TECHNICAL BULLETIN TR-14 (REV.)

DATE: MARCH 21, 2001
MODEL YEAR: 1995 AND AFTER
CHASSIS MODEL: UD1800HD ~ UD3000
TRANS. MODEL: MLS61B
BULLETIN #: TR - 14 (Revised to include synchronizer kit part numbers)
FILE IN THE TRANSMISSION SECTION OF THE TECHNICAL BULLETIN BINDER

MLS61B TRANSMISSION SYNCHRONIZER PART NUMBER CHANGES

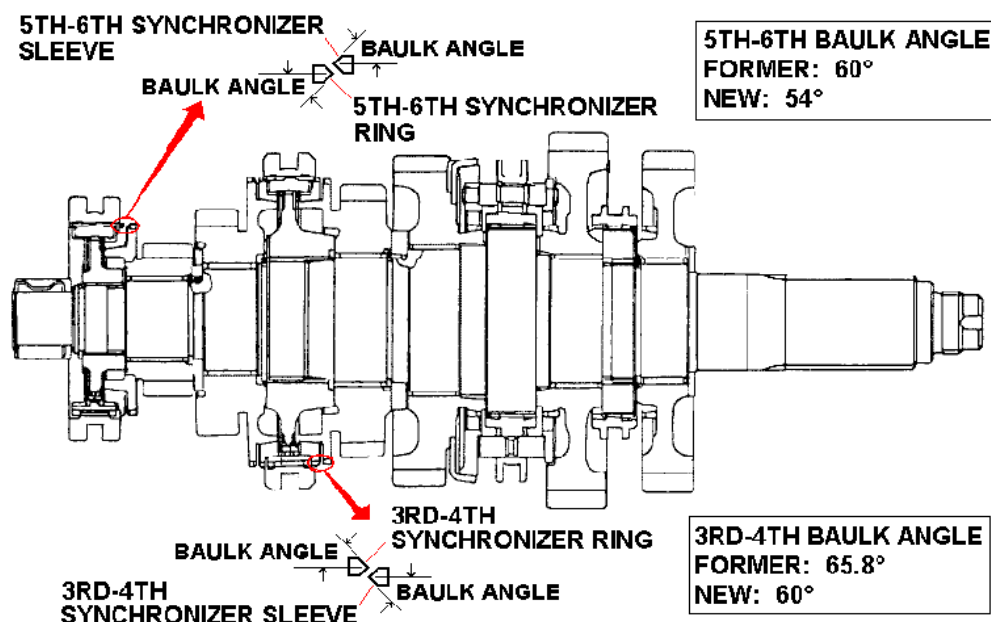
The baulk angles of the 3rd ~ 4th and 5th ~ 6th gear synchronizer rings and sleeves have changed as illustrated below.

These synchronizers should be used when replacing the 3rd ~ 4th and 5th ~ 6th gear synchronizers in MLS61B transmissions in 1995 ~ 1998 model year vehicles, and in 1999 model year vehicles with Vehicle Identification Numbers prior to the VIN list shown above.

NOTE: These synchronizers and their component parts are not interchangeable with former part numbers for the 3rd ~ 4th and 5th ~ 6th gear synchronizers. All parts listed in the cell chart must be used as a set.

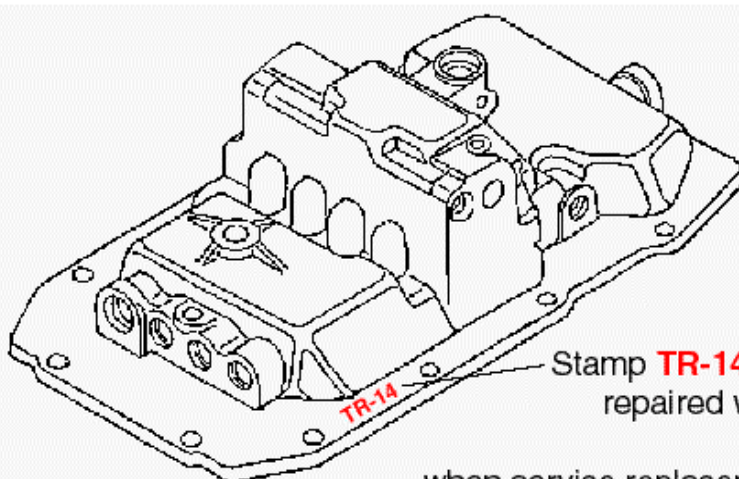
- (a). 1995 ~ 1998 model year vehicles,
- (b). 1999 model year vehicles with Vehicle Identification Numbers prior to the VIN list provided, or
- (c). when replacing the complete transmission with a service replacement assembly with a manufacture date after April, 1998, the transmission shift cover must be stamped with the letters TR-14. This will indicate to future service technicians and parts departments that the unit already contains these current 3rd ~ 4th and 5th ~ 6th gear synchronizers.

Stamp the transmission shift cover between the shift cover bolt holes on the front left side as shown below.

Stamp **TR-14** at this location on transmissions repaired with the new synchronizer sets
OR
when service replacement transmission assemblies are installed
